Re: Railway (Metrolink - Estuary to Charlemont via Dublin Airport) Order [2022]
Metrolink. Estuary through Swords, Dublin Airport, Ballymun, Glasnevin and City Centre to
Charlemont, Co. Dublin

RAILWAY (METROLINK-ESTUARY TO CHARLEMONT VIA DUBLIN AIRPORT)
ORDER 2022

RE: SUBMISSION ON THE METROLINK RAILWAY ORDER APPLICATION IN
RELATION TO THE SITE OF A COMMERCIAL DEVELOPMENT AT 2 GRAND
PARADE, RANELAGH, DUBLIN 6.

RAILWAY ORDER
Charlemont Station Observation

Figure 4: Extract from plan number ML-P 307 O-A (Railway Works MetroLink- Property Details Grand Parade to Northbrook Road)

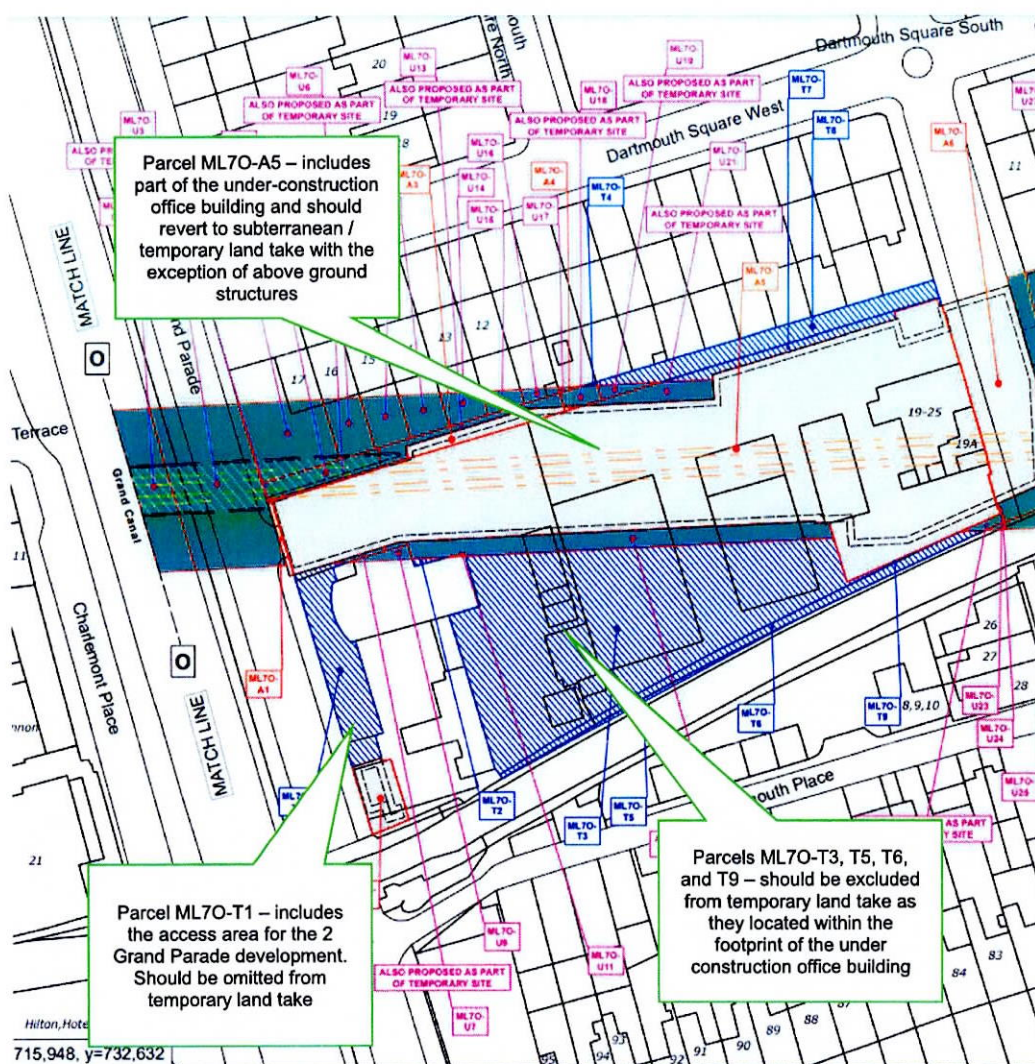
As noted above, the land acquisition mapping forming part of the Railway Order application indicates the entire site in the ownership of our client (with the exception of the existing Carroll's Building) within the permanent and temporary land take for the MetroLink project.

It appears that this may represent a mapping error which should be clarified prior to the granting of a Railway Order or any associated Compulsory Purchase Order. As currently indicated, the land acquisition details illustrated on the Property Details drawings would not be acceptable to our client.

As noted in the figure below, parts of the permanent and temporary land take illustrated at 2 Grand Parade actually fall within the built footprint of the office development which is nearing completion on site (as permitted under Reg. Ref.: 2372/17 / ABP Ref.: 300873-18, as amended by Reg. Ref.: 4755/19 and Reg. Ref.: 3486/20 / ABP Ref.: 309011-20). Therefore these areas of the site are not suitable either for temporary or permanent acquisition.

It is submitted that the extent of permanent land take should be revised to take in only the elements of ground-level development proposed as part of the Charlemont station (i.e. escalators, vents, station building etc.).

Similarly, the temporary land take should be reduced to cover areas which will actually be required (and available) for use during the construction phase. This must exclude the footprint of the office building under construction and nearing completion on site, along with any lands necessary to maintain the access, underground services and operation of the office development.

Figure 6: Extract from 2GP Permitted Planning Drawing 950231 PL1010 Reg. Ref.: 3486/20, with the location of the proposed escalators and extent of access road in blue, and fire escape route denoted by green arrow

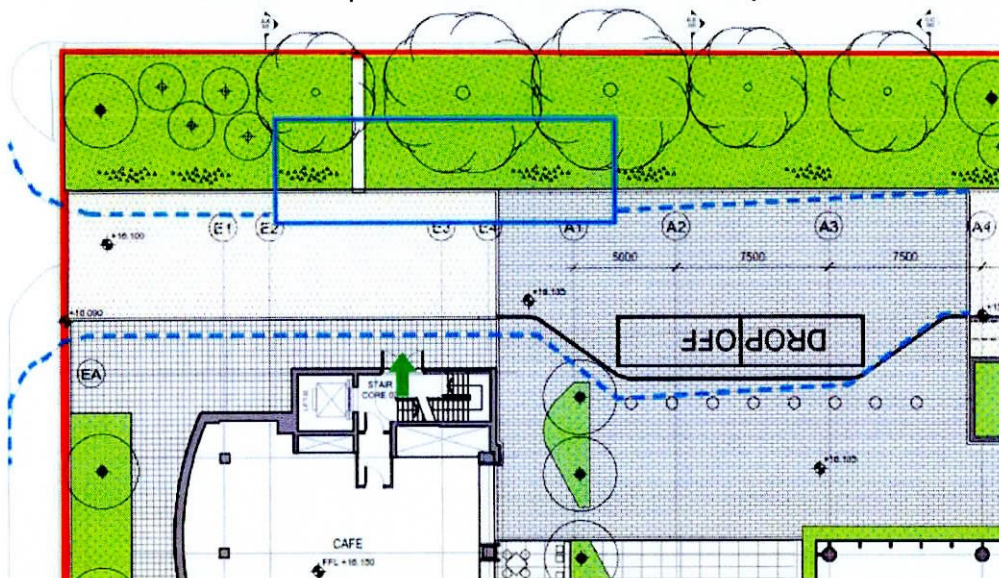
- Part of the permitted 2 Grand Parade scheme is a 6m roadway to access the development (with the width of the access based on two-way car traffic, fire access, cyclists, and to accommodate perpendicular parking). The escalators proposed would reduce the width of the access to an extent which would interfere with the accessing of the development.

- This will also result in the realignment of the internal access road and of the main vehicular executive Drop-Off, impacting on the landscaped atrium plaza and alignment with the building entrance configuration, and on the removal of 5 no. existing trees adjacent to Dartmouth Lane (the eastern boundary of the site).

- The design currently does not indicate a kerb along side the escalators (which would be required) and this would further obstruct the access to the 2 Grand Parade development.

- In addition to this, the MSA note states that this aspect of the design would have an adverse effect on escape from the 2 Grand Parade development via stair core 2.

Having regard to the foregoing, revisions should be made to the Railway Order application drawings and documents, to ensure that a minimum 5.5 metre carriageway and a 2-metre paved footpath to maintain adequate access (including fire access).

Fig 02A Extract from submission drawing ML1-JAI-ARD-ROUT_XX-DR-Y-02090

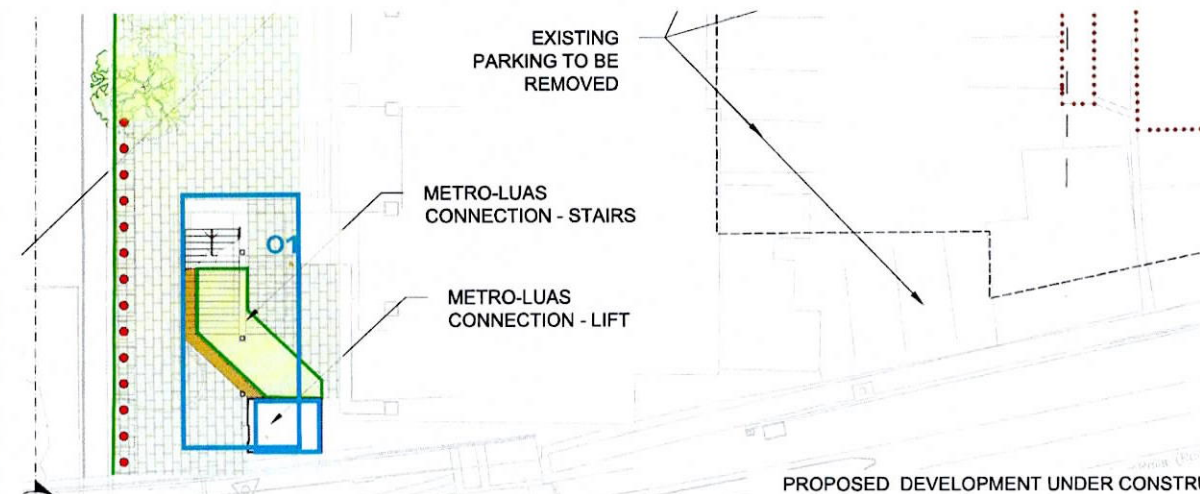
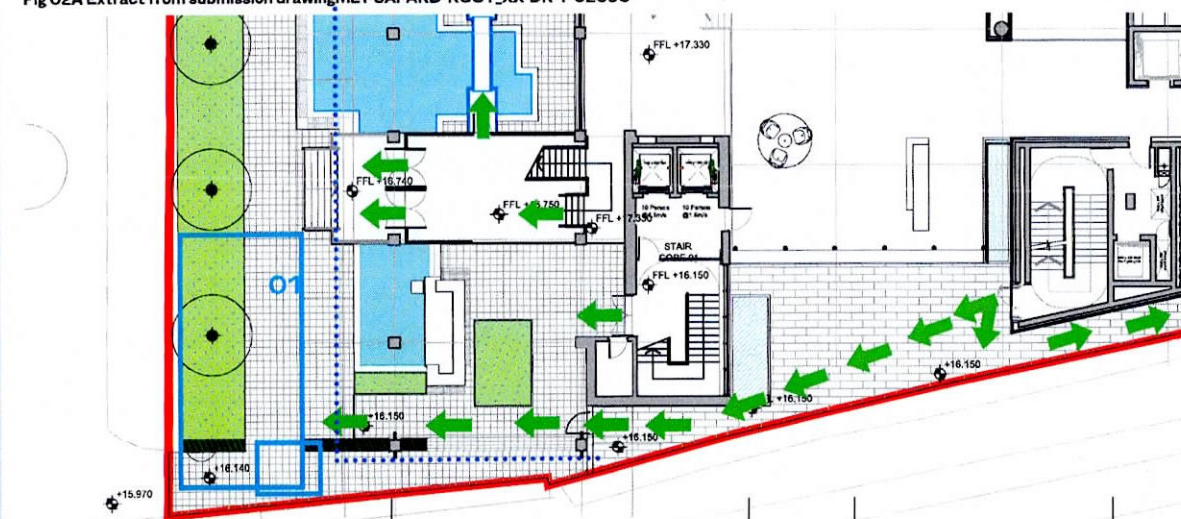
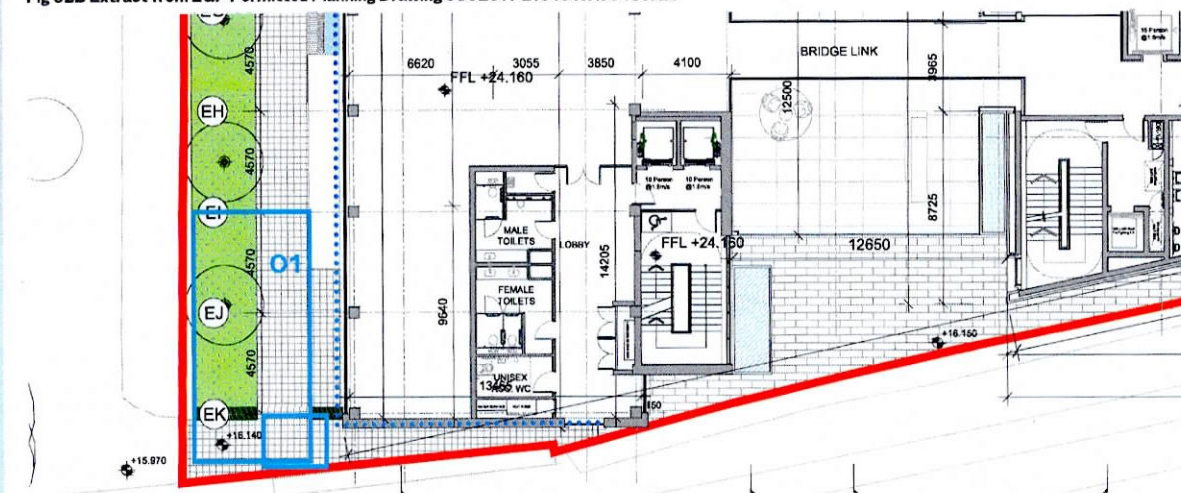
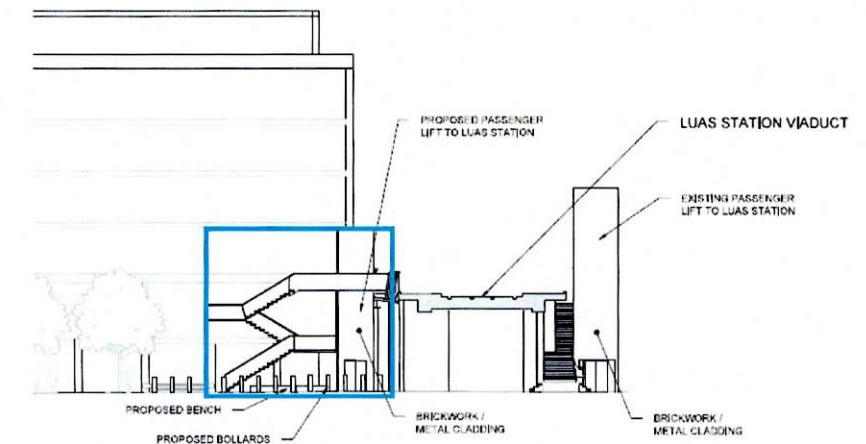
- There will be privacy issues with the pedestrian route from the lift and stair passing directly past the office windows - see Fig 02C.

The lift and stair configuration as proposed are a concern to the 2GP development and at a minimum we suggest the relocation of the lift to an alternative location, potentially to the opposite side of the Grand Parade road adjacent to the canal, and the reconfiguration of the staircase to address the observations noted above.

In Fig 02B, the proposals for the Luas link lift and stair are outlined in blue on the 2GP site layout plan to assist in demonstrating the close proximity of the proposals to the 2GP building and the impact it would have on a main fire access and egress route linking the 2GP escape stairs directly through the proposed stair and lift location to the road at Grand Parade.

In Fig 02C, the proposals for the Luas link lift and stair are outlined in blue on the 2GP second floor plan to assist in demonstrating the close proximity of the proposed lift and stair to the glazed facade of the 2GP building.

Fig 01A Extract from submission drawing ML1-JAI-ARD-ROUT_XX-DR-Y-02090

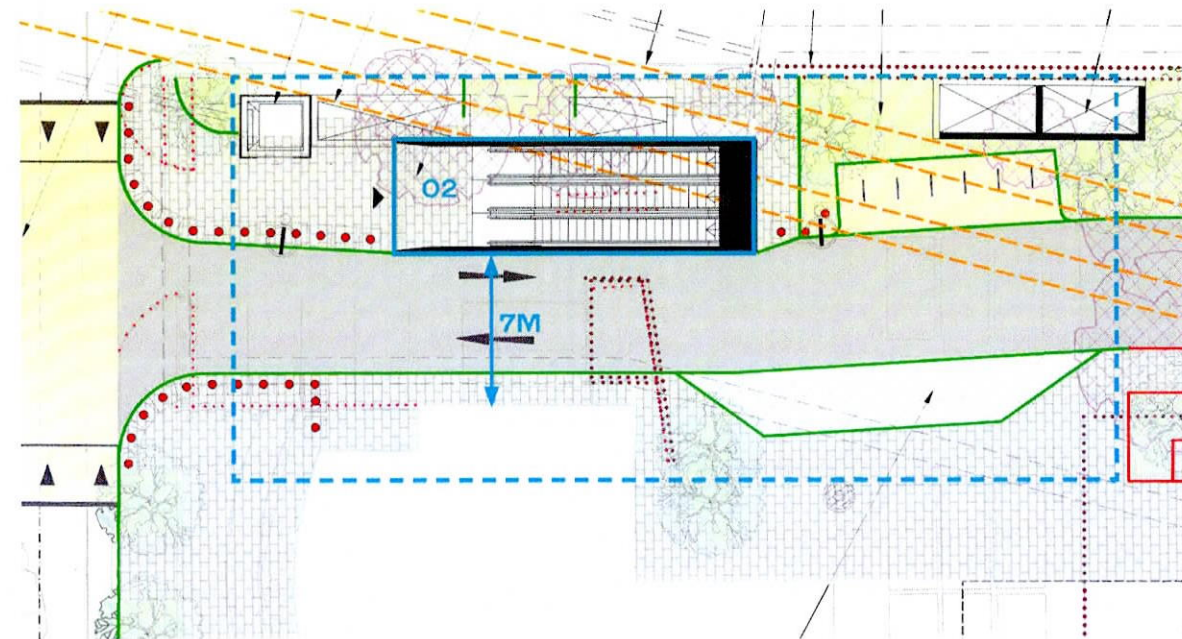
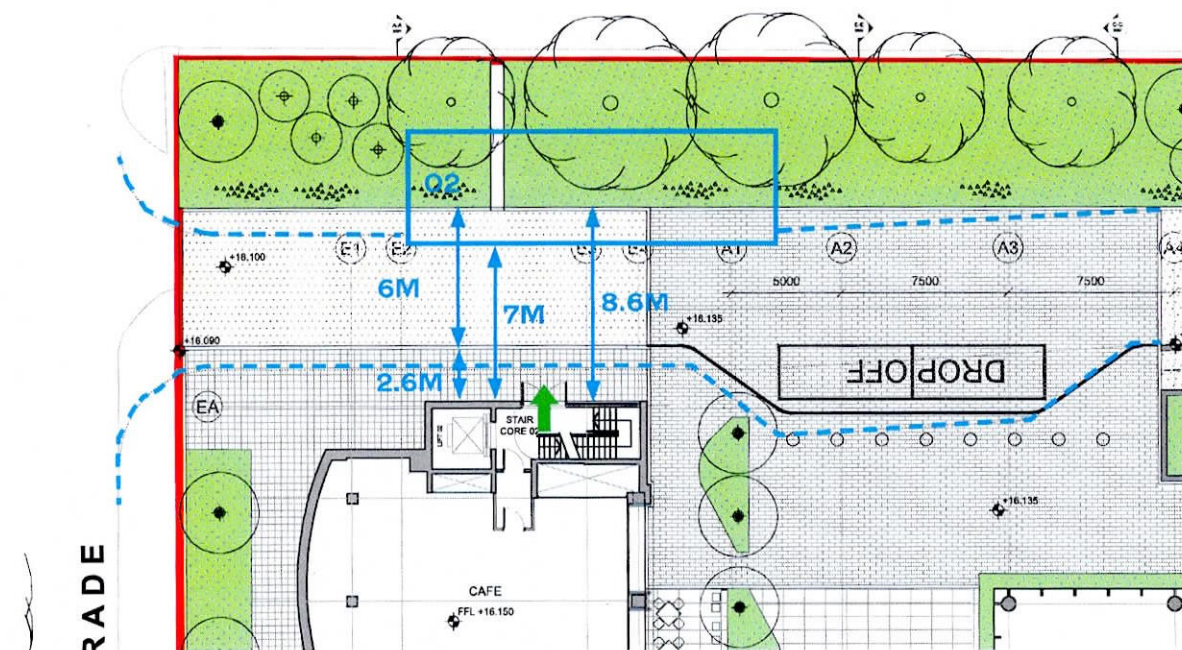
This would also allow the parallel Drop-Off zone configuration to be maintained. Our client would be concerned that anything less than this provision would curtail the operation of the permitted development currently under construction on site.

In addition, there are 5no. trees that are protected under the 2GP planning permission located along the Dartmouth Lane perimeter that will be impacted by the proposals that will need consideration. We request that the location and design of the escalators and the lift be considered further, and amendments introduced prior to the granting of a railway order.

In Fig 01B, the metro proposals for the escalators and roadways are outlined in blue on the 2GP site layout plan to assist in demonstrating the impact of the proposed reduction in the road and paved zone widths and splayed Drop-Off zone.

Fig 03A Extract from submission drawing ML1-JAI-ARD-ROUT_XX-DR-Y-02090

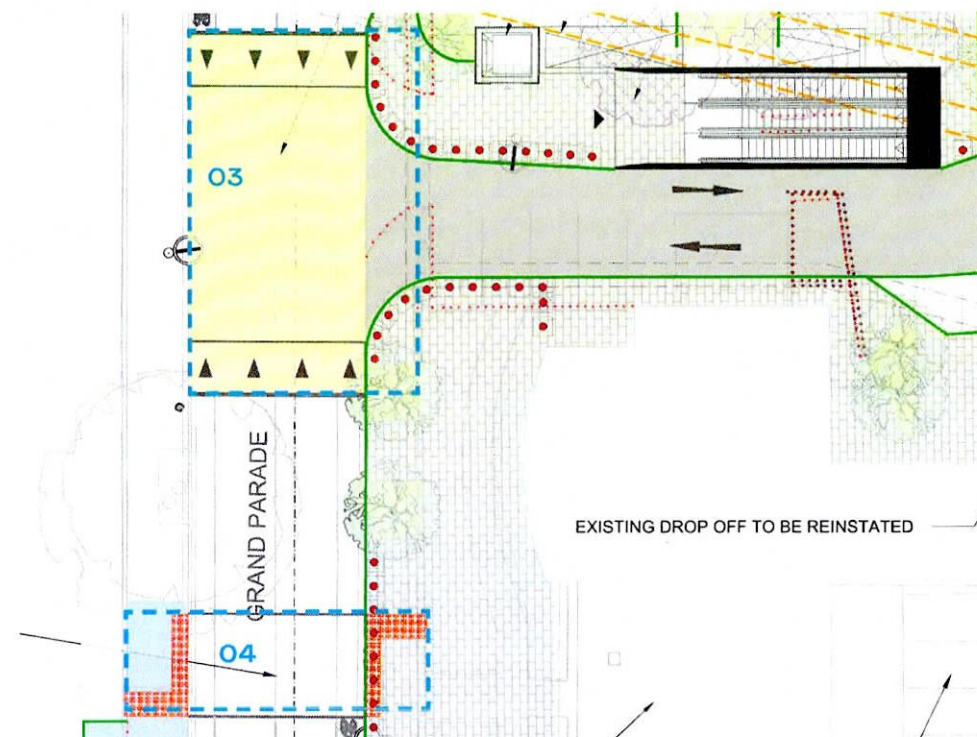
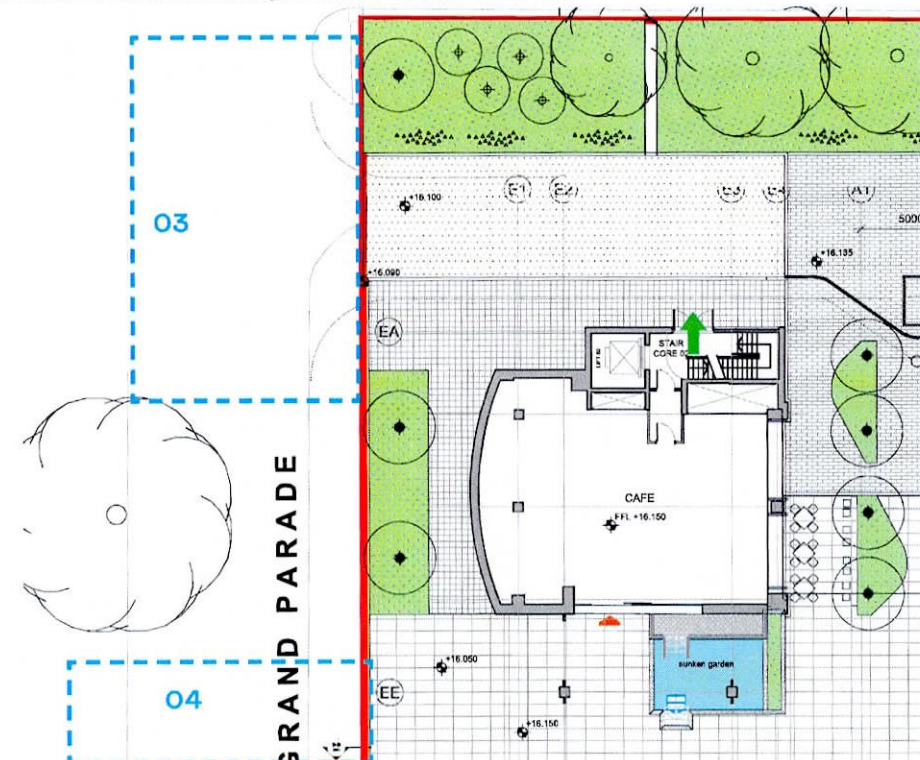
Clarification is sought on the details of these crossing locations and anticipated use/pedestrian flows from each crossing that will direct pedestrians through the 2GP development.

This further detail should be provided prior to the granting of any railway order.

Fig 5A Extract from submission drawing ML1-JAI-ARD-ROUT_XX-DR-Y-02090

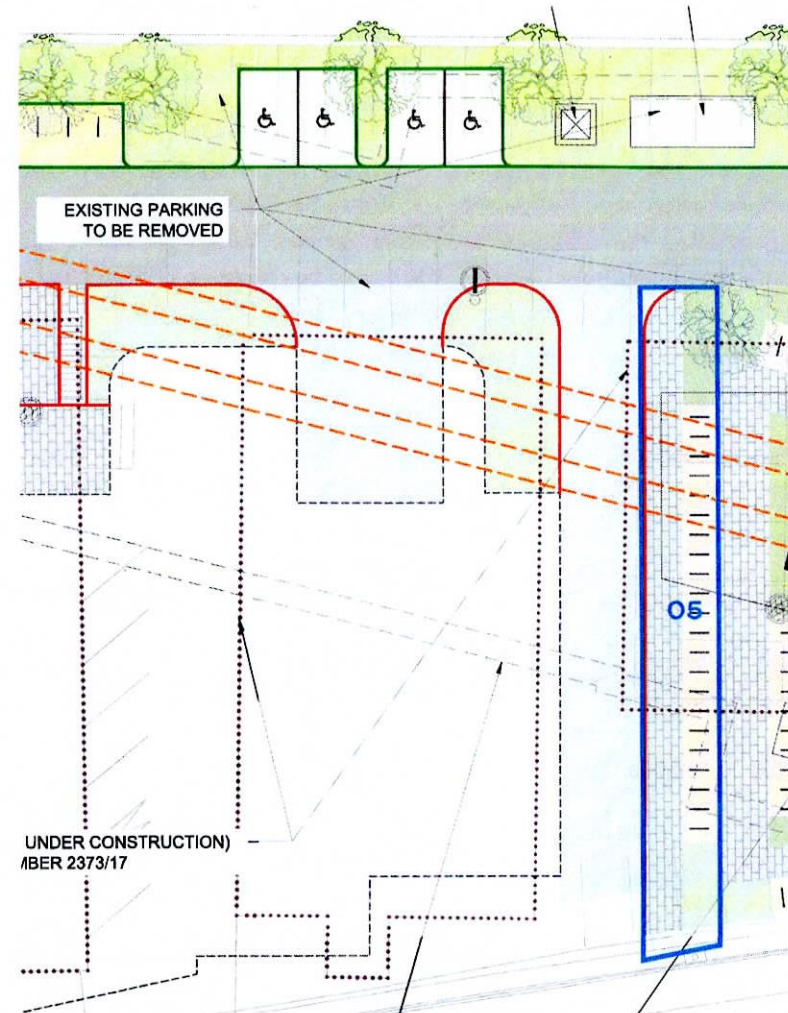
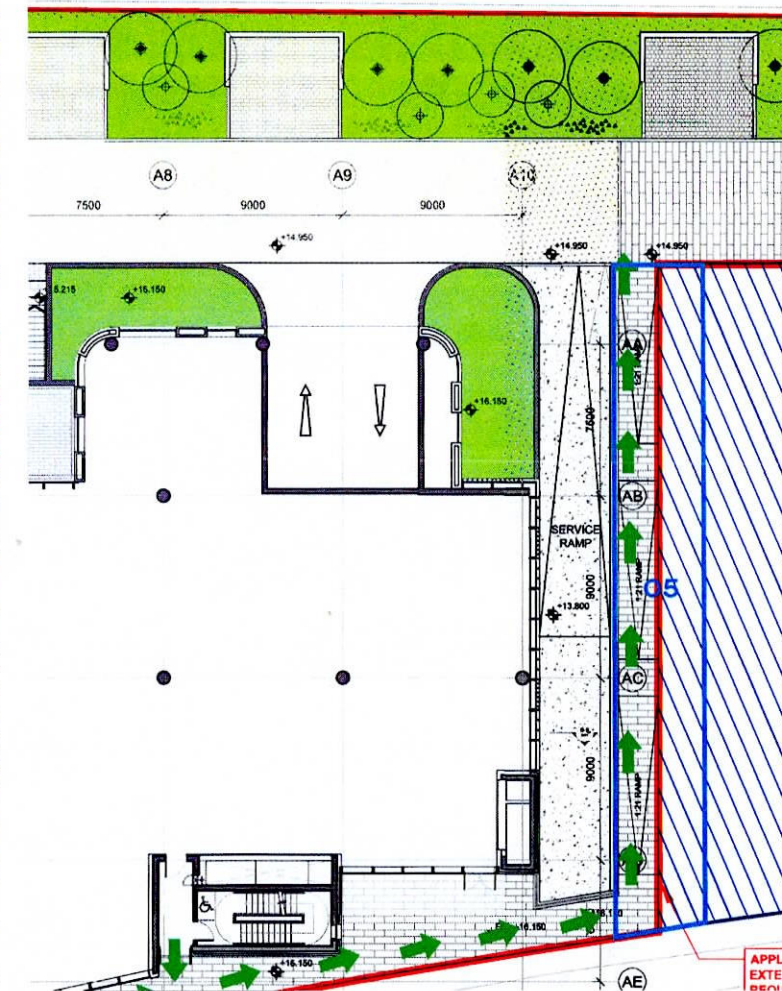
The proposed bicycle parking and associated circulation area to the north of the cycle stands extends into the 2GP development - see Fig 05A and 05B with blue outline,

A clear zone as indicated in Fig. 05B provides a designated fire escape access and egress route which will be compromised by the current bicycle parking configuration and consideration taken to limit access to the cycle stands from the southern side, on this basis, the cycle parking should be reconfigured to avoid impacting on this route.
